JOINT REGIONAL PLANNING PANEL
(Sydney East Region)

JRPP No	2016/SYE031
DA Number	LDA 2015/0654
Local Government Area	City of Ryde
Proposed Development	Demolition of existing buildings, amalgamation of the lots and construction of a mixed use development containing a total of 105 residential units & 269m ² of commercial floor space.
Street Address	723-731 Victoria Road, 10 Little Church Street and 3-7 St. Anne's Street Ryde
Applicant	CDArchitects
Number of Submissions	To the original proposal: 13 submissions received To the amended proposal: 3 submissions received
Regional Development Criteria (Schedule 4A of the Act)	General Development over \$20 Million Cost of Works:\$34,144,723
List of All Relevant s79C(1)(a) Matters	<ul style="list-style-type: none"> • Environmental Planning and Assessment Regulation 2000; • Environmental Planning and Assessment Act 1979; • State Environmental Planning Policy (State and Regional Development) 2011; • State Environmental Planning Policy (Infrastructure) 2007; • State Environmental Planning Policy No. 55 – Remediation of Land; • State Environmental Planning Policy (Building Sustainability Index: BASIX); • State Environmental Planning Policy No 65

Figure 18 – separation between adjoining site at 721 Victoria Road. One window facing 721 Victoria Road which is off a study area and has opaque glass.

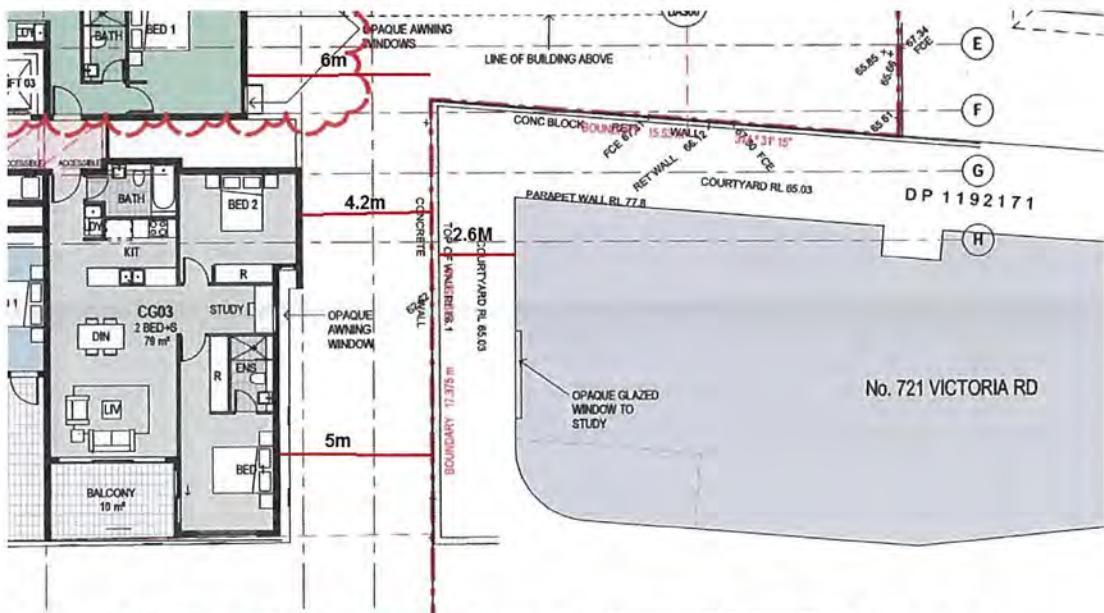
*1 Building Separation/visual privacy

The proposal does not comply with the minimum separation distance of 6m (Ground – Level 3) or 9m (Levels 4 and 5) to the eastern and southern side boundary shared with No. 721 Victoria Road, see **Figure 18** below. Despite the numerical non-compliance, the reduced setback is acceptable as there are a limited number of windows on the elevation, any proposed windows relate to low activity areas of the unit such as studies or bedrooms and the windows are treated with opaque glass or privacy screening to orient the view to Victoria Road. In addition, the western elevation of the building at No. 721 Victoria Road does not have living room windows or private open space areas oriented to the side of the proposed development. The variation in the building separation was also supported by the UDRP. The variation to the separation requirement is acceptable in this case.

Figure 19: Typical layout of apartment C03. Condition 1(a) imposed to provide north facing window to bedroom 2 to improve solar access to the room.

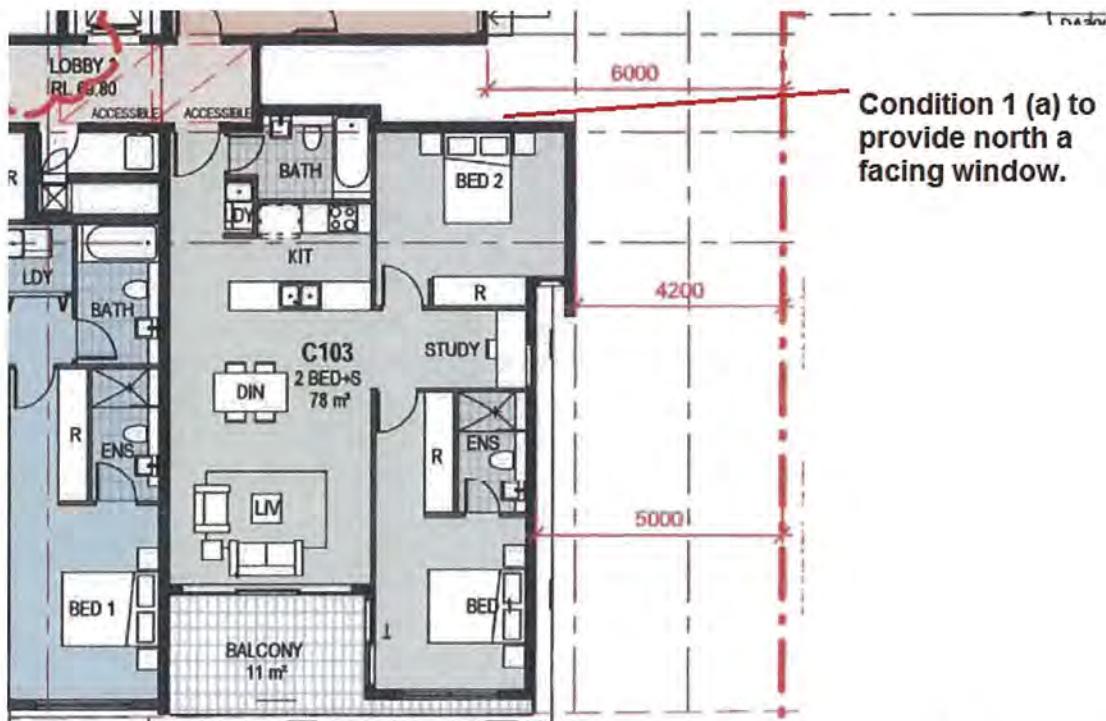
Nevertheless, the proposal satisfies the objectives of optimising the number of apartments receiving sunlight to habitable rooms, primary windows and private open space. 71.4% of the apartments will receive 2 hours of solar access. In addition, to further improve amenity to five units, **Condition 1(a)** has been included to provide a north facing window to Bed 2 of units CG03, C103, C203, C303 and C403. See **Figure 19** below.

Figure 21 – Overshadowing at 9am – some overshadowing to the north west corner of 721 Victoria Road.

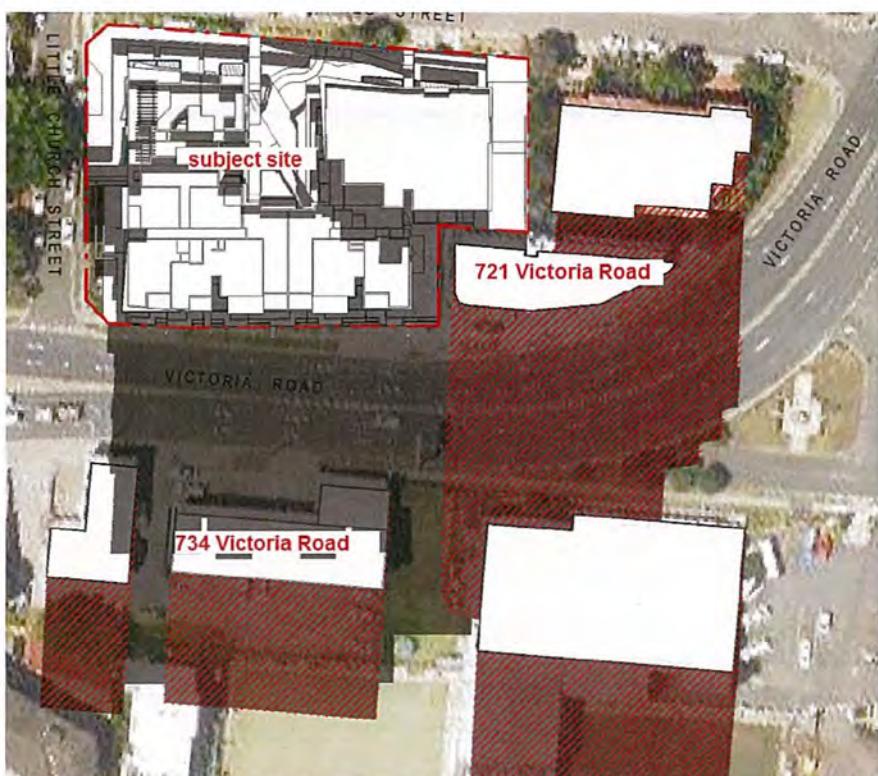
The DCP requires the built form of new development to be designed to minimise shadow impacts on surrounding properties. The submitted diagrams demonstrate that shadow casted by the proposed development will impact the north facing corner units on the adjoining property at No. 721 Victoria Road. The remaining shadows will be cast over Victoria Road which is located to the south of the site. Given the orientation of the site any redevelopment at St Annes Street will overshadow the adjoining southern site, in this case, 721 Victoria Road. It should also be noted that 721 Victoria Road is a remnant site with reduced setbacks. The proposed development predominantly complies with the required setback and complies with the

height where the site adjoins 721 Victoria Road. It is considered the shadow impact of the proposal is acceptable given that the overshadowing is only for a small section of 721 Victoria Road, and the height and setback of the buildings are generally in accordance with council's LEP and DCP controls.
